RENESAS TECHNICAL UPDATE

Product Category	MPU & MCU	Document No.	TN-16C-A196A/E	Rev.	1.00
Title	Errata to R32C/156 Group Hardware Manual		Information Category	Technical Notification	
Applicable Product	R32C/156 Group	Lot No.	Reference Document	R32C/156 Group Hardware Manual Rev. 1.03 (REJ09B0506-0103)

This document describes corrections to the R32C/156 Group Hardware Manual, Rev. 1.03.
The corrections are indicated in red in the list below.

Figure 7.1 Clock Generation Circuitry

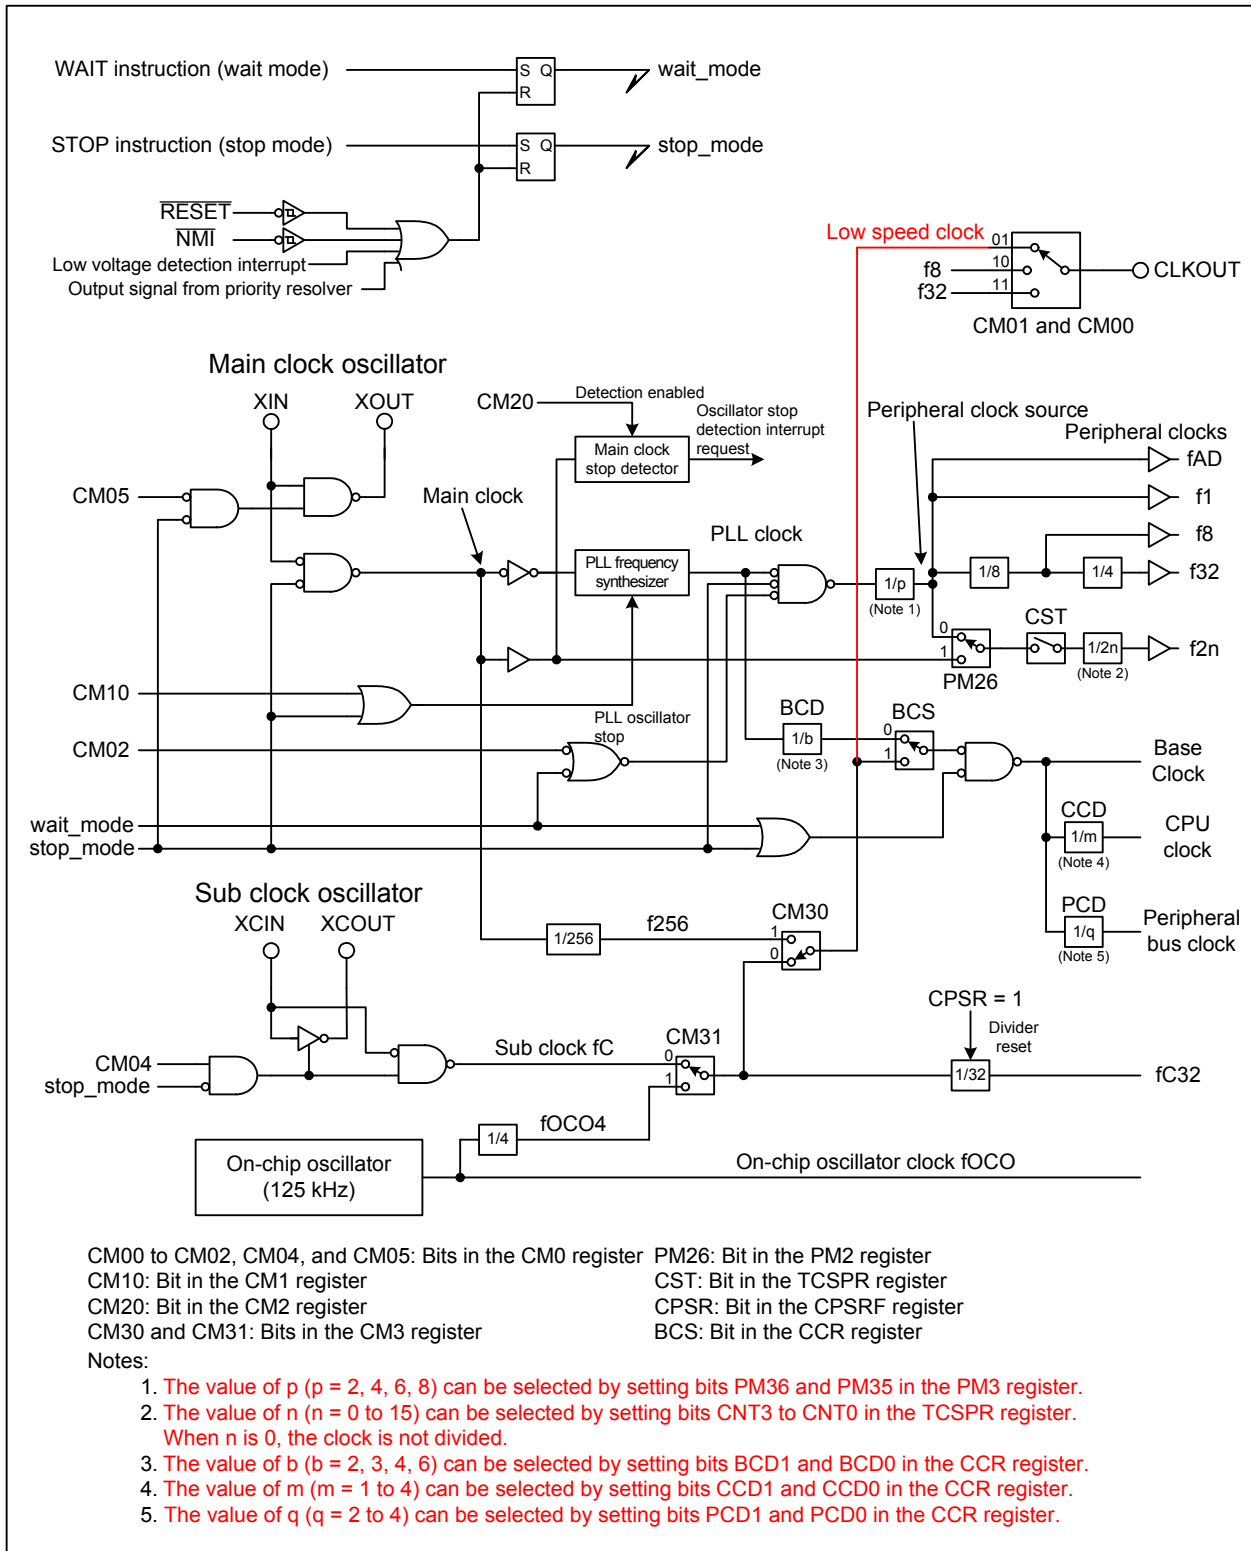
•Page 90 of 621, Figure 7.1 is corrected as follows:

Figure 7.20 State Transition (when the on-chip oscillator clock is used)

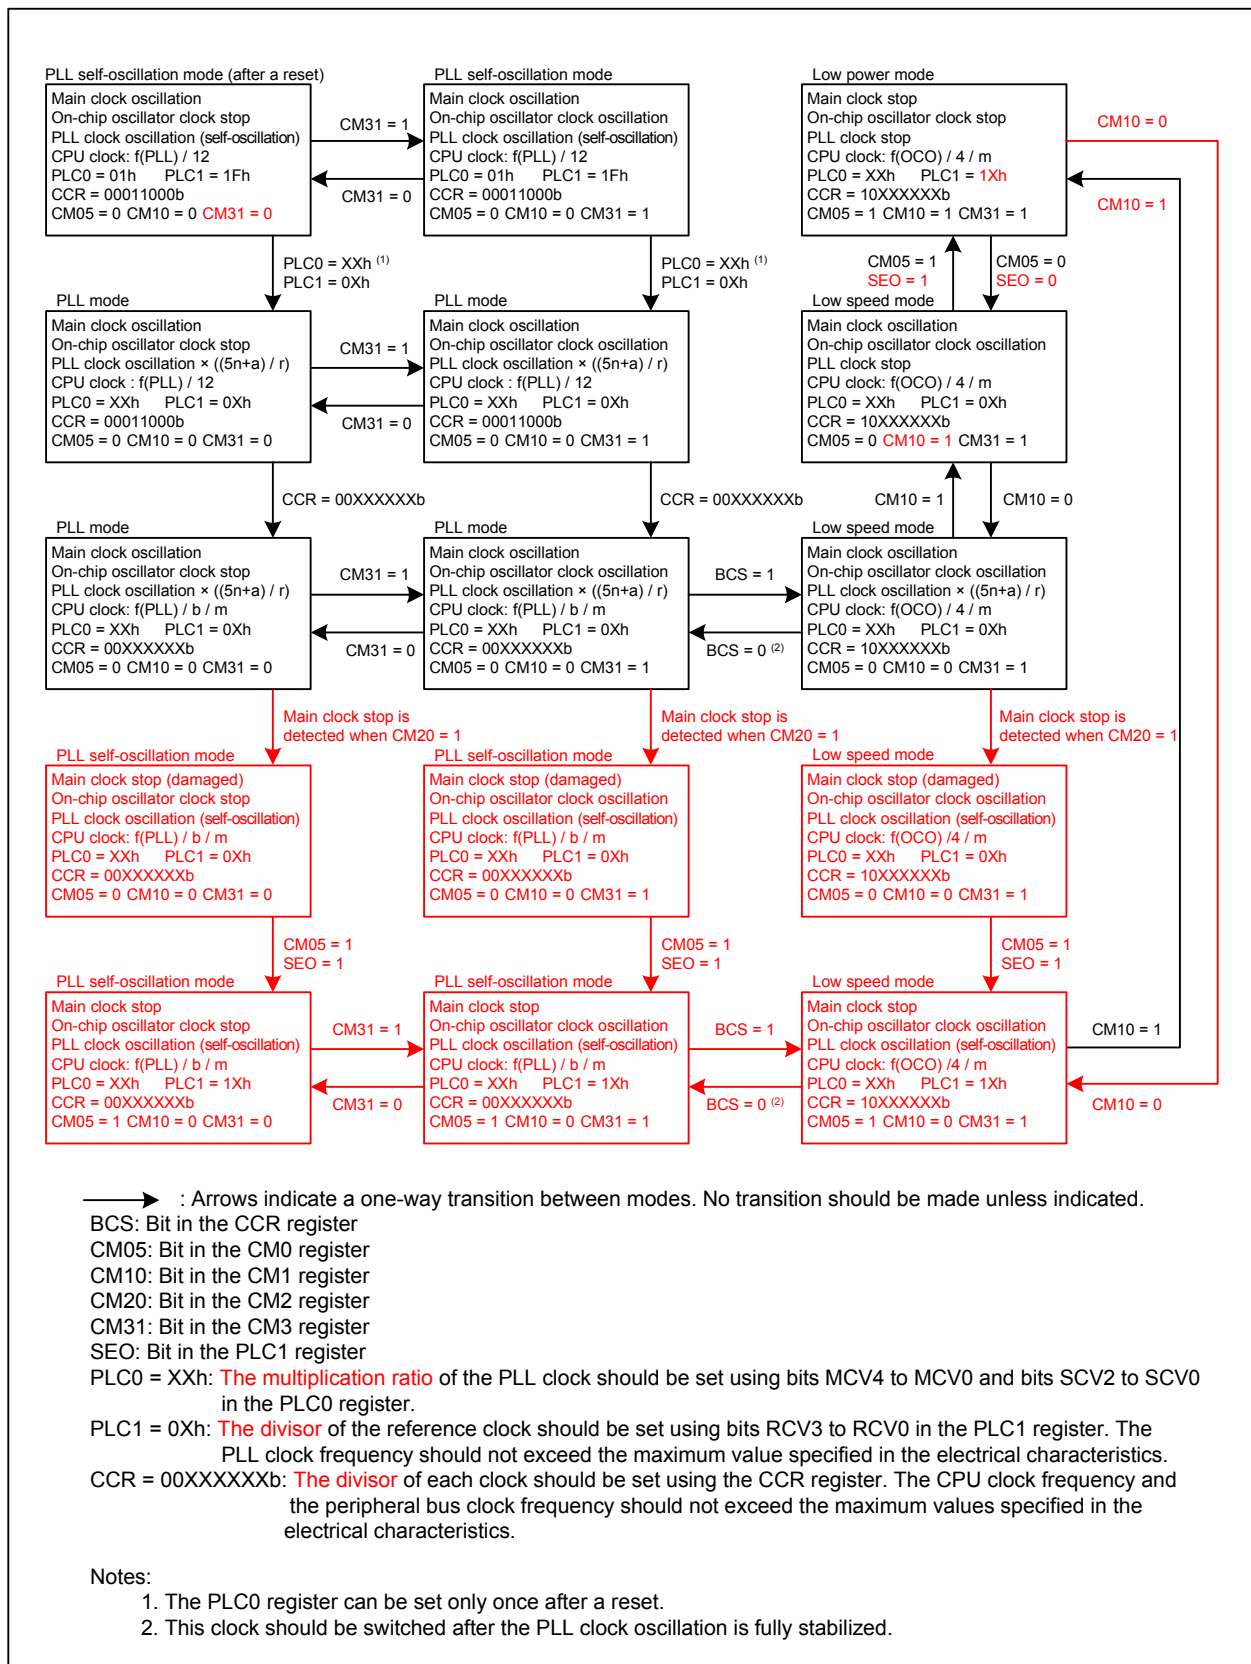
•Page 110 of 621, descriptions “CM31 = 1” in the first row and “CM10 = 0” in the second row in Figure 7.20 are corrected, and the state transition is modified as follows:

(Note 3 “The CM05 bit is not set to 1 when an oscillator stop is detected through the oscillation stop detector.” is deleted from Figure 7.20)

Figure 10.8 Priority Resolver

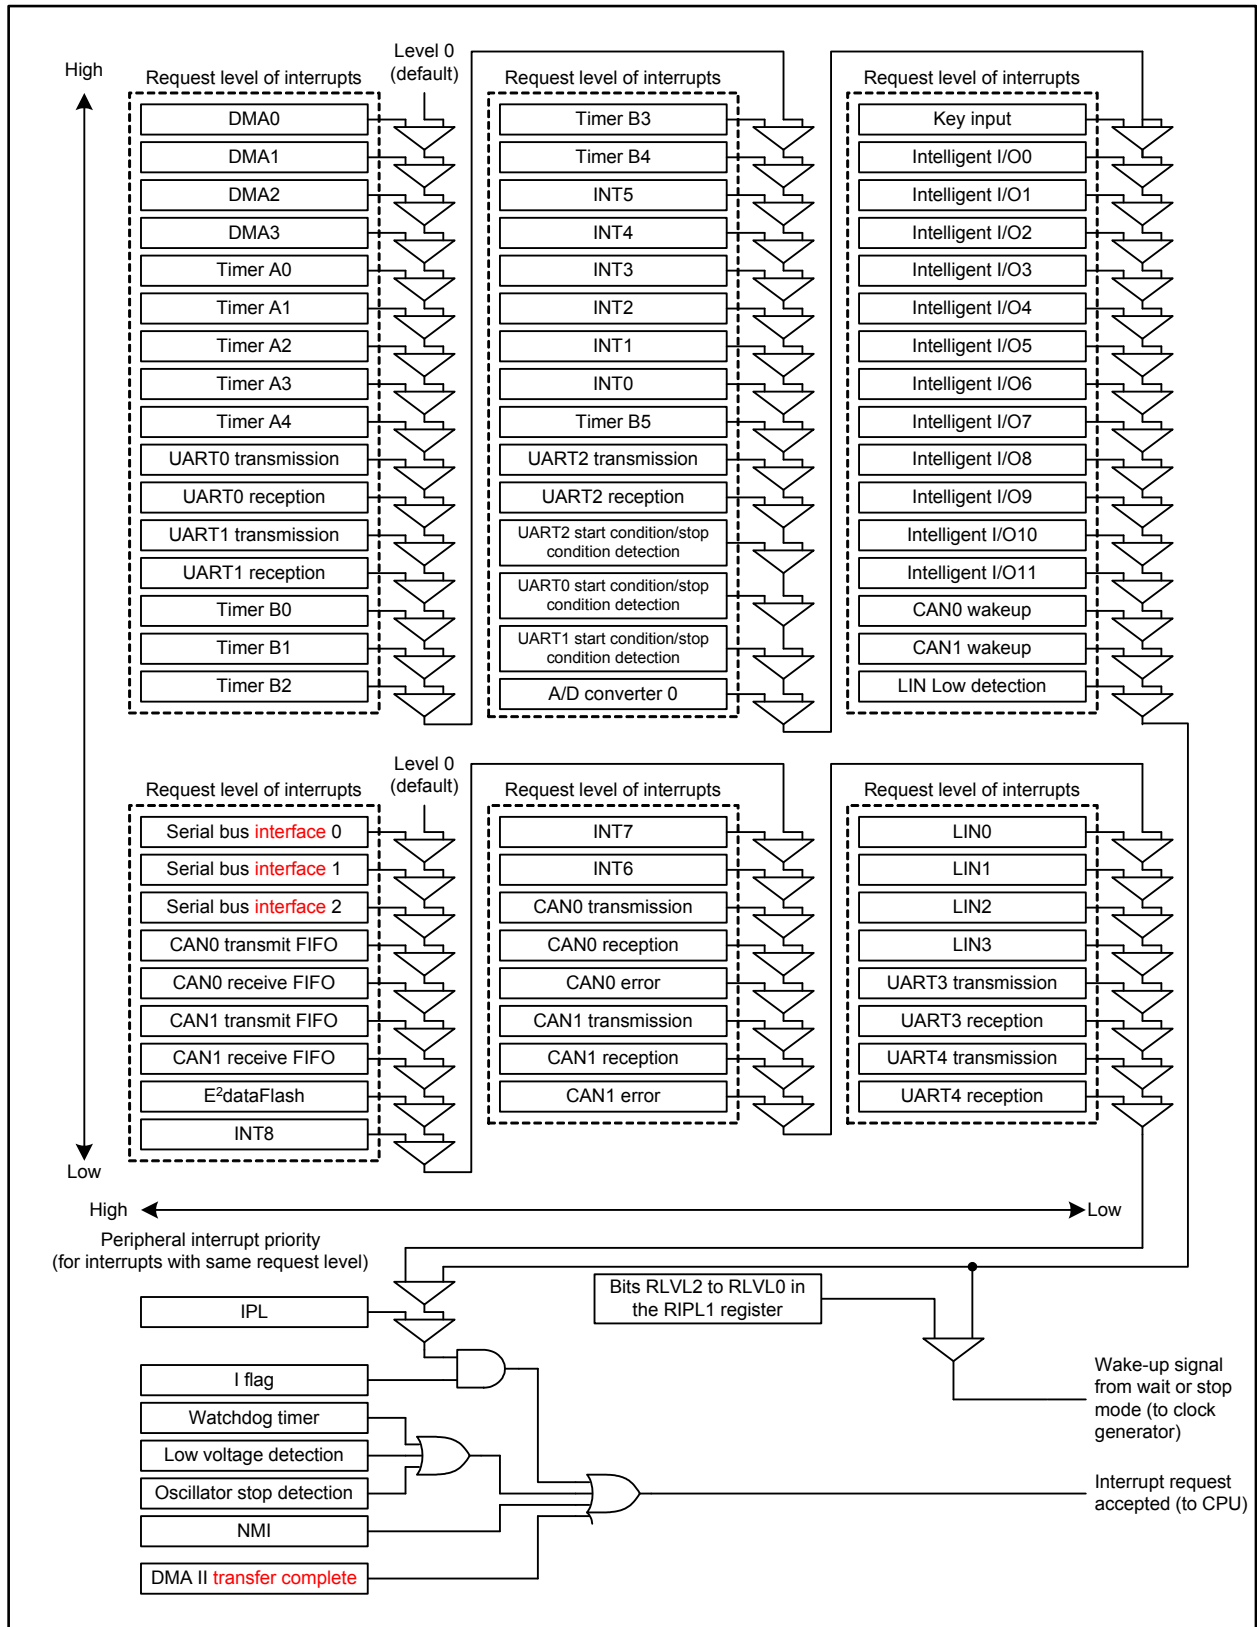
•Page 142 of 621, Figure 10.8 is corrected as follows:

(Description "Bits RLVL2 to RLVL0 in the RIPL2 register" and associated signal lines are deleted from Figure 10.8)

Figure 15.2 Timer B Configuration

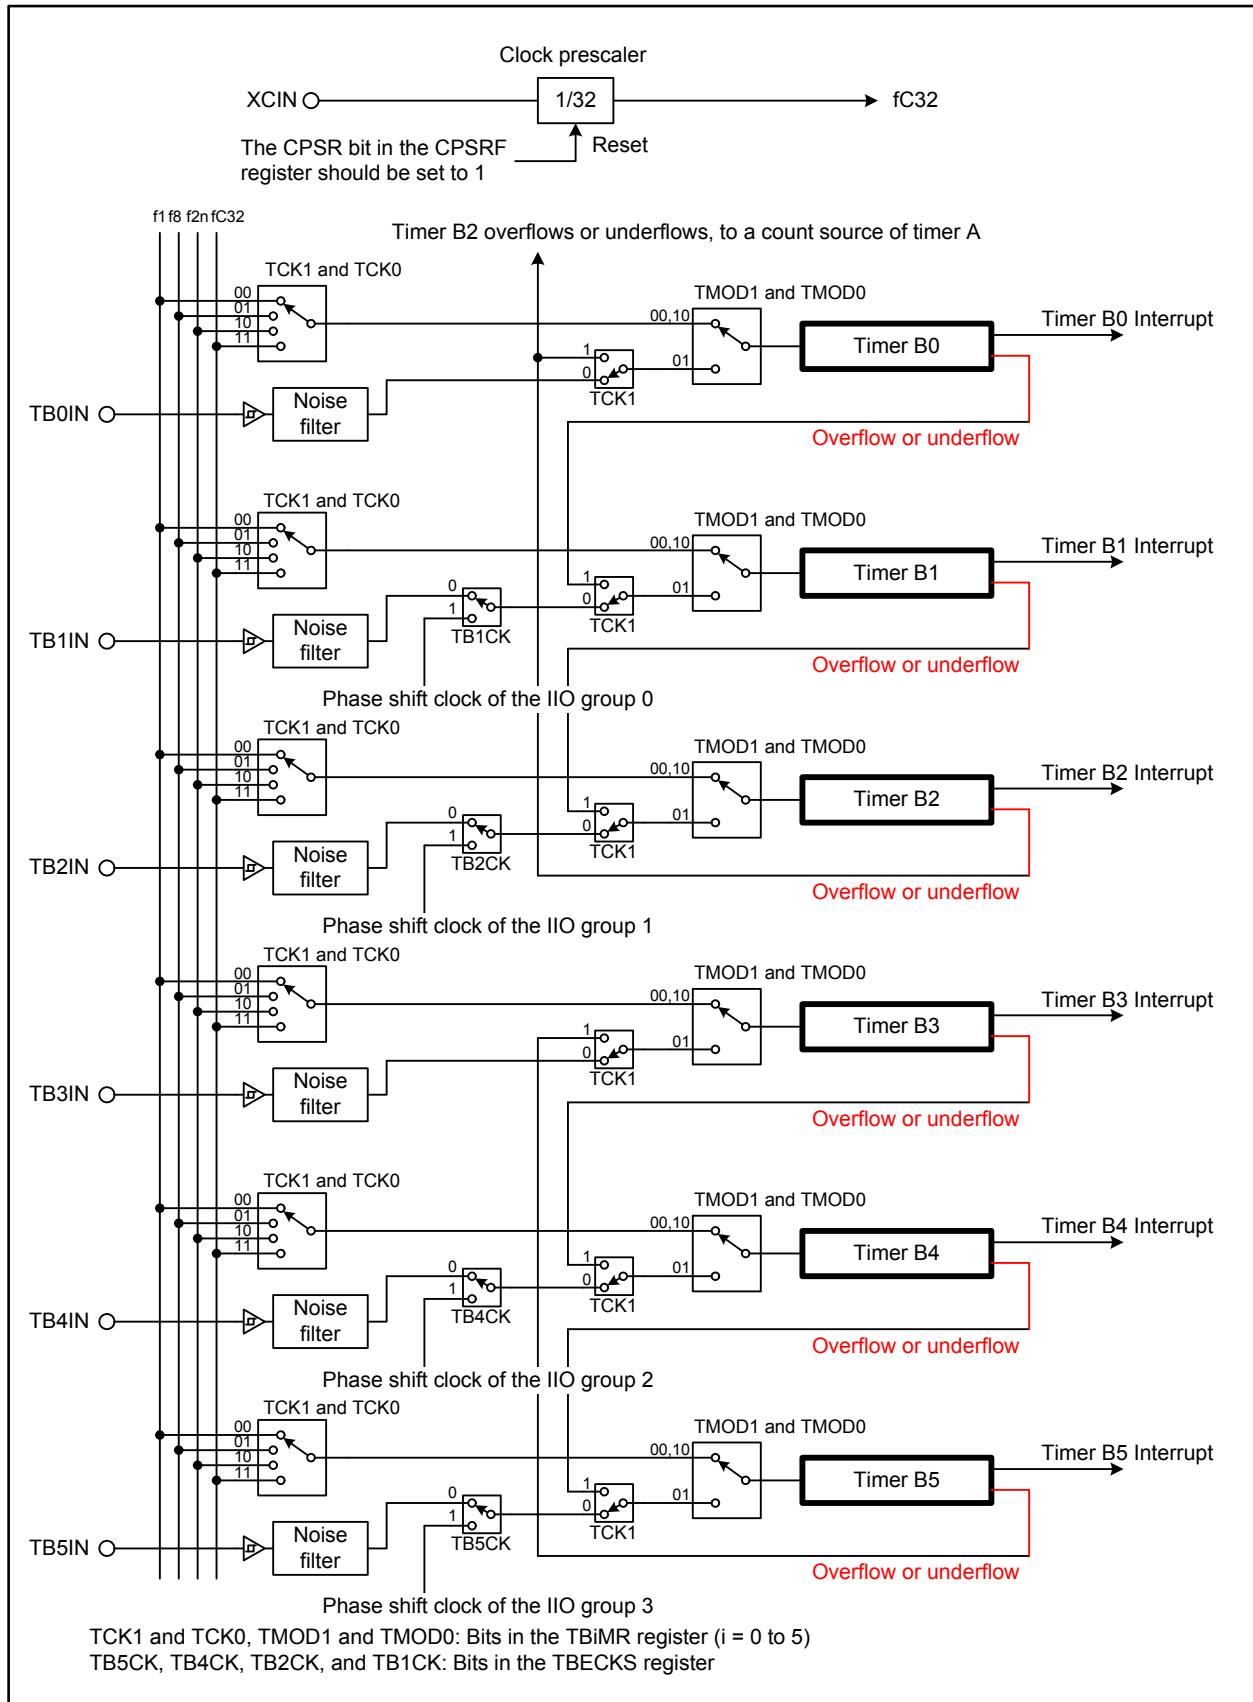
•Page 184 of 621, Figure 15.2 is corrected as follows:

Figure 24.30 Example of Setting Before Transition to Wait Mode

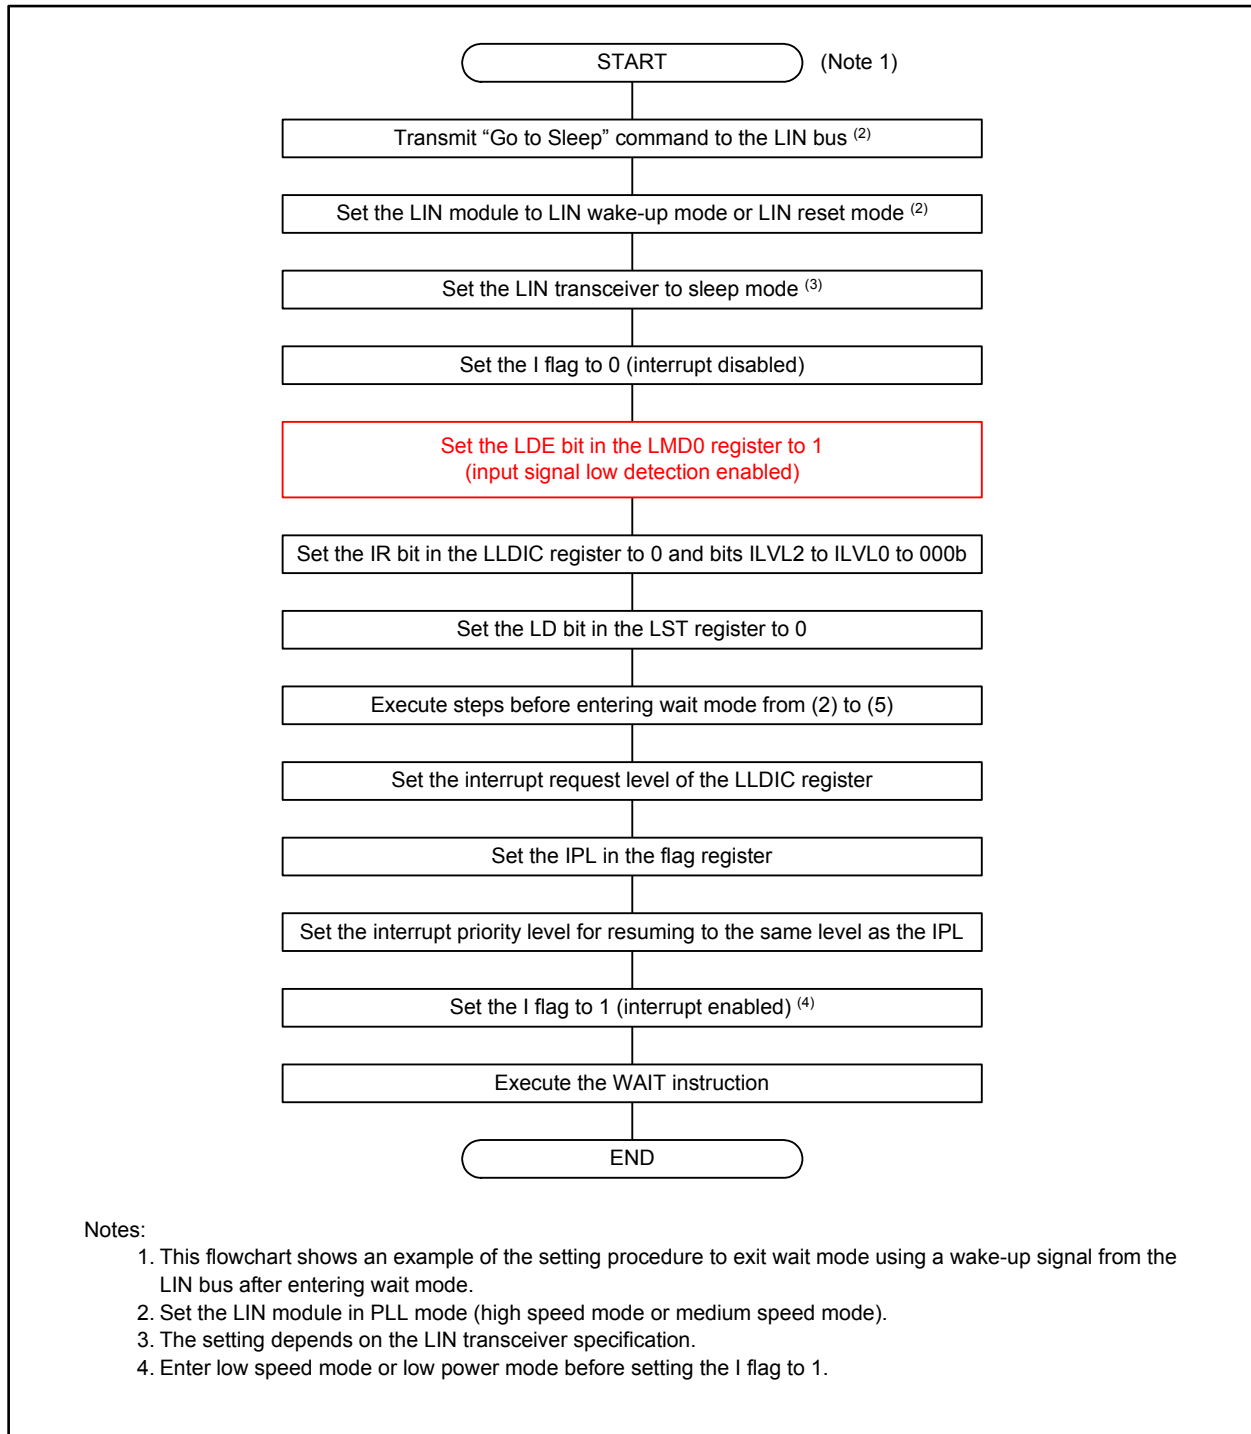
•Page 418 of 621, Figure 24.30 is corrected as follows:

Figure 24.32 LINj Interrupt Block Diagram (j = 0 to 3)

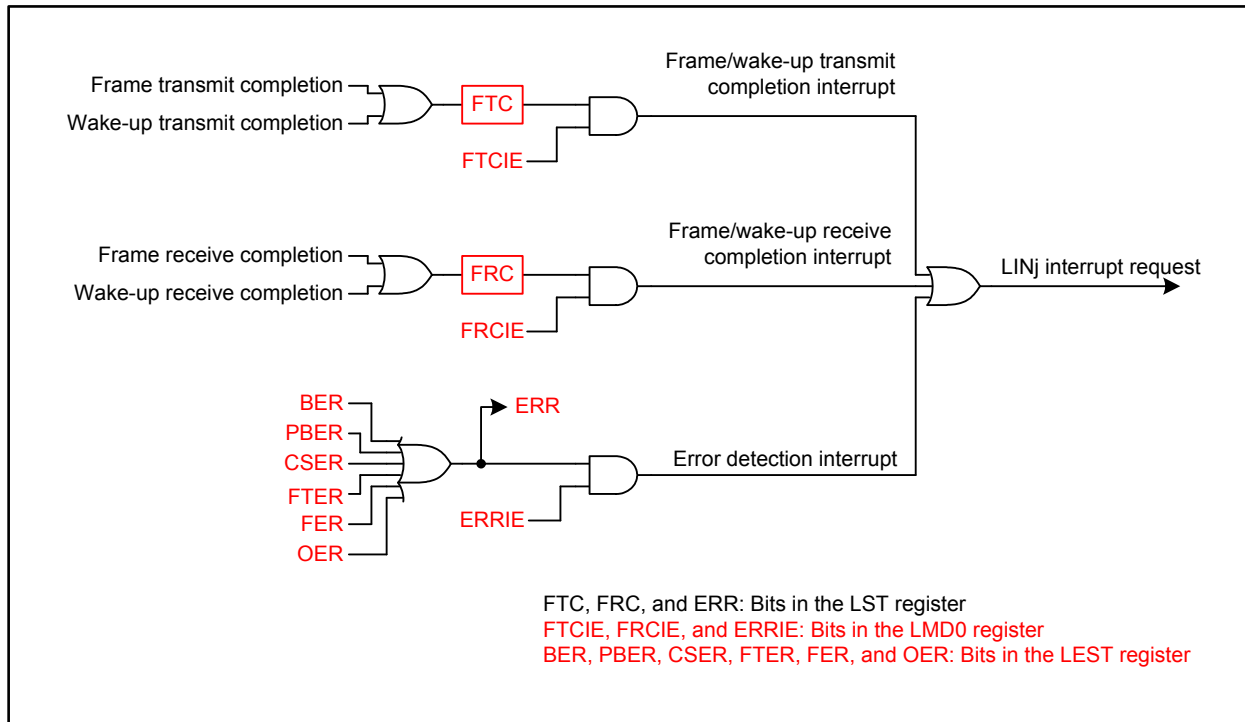
- Page 422 of 621, Figure 24.32 is corrected as follows:
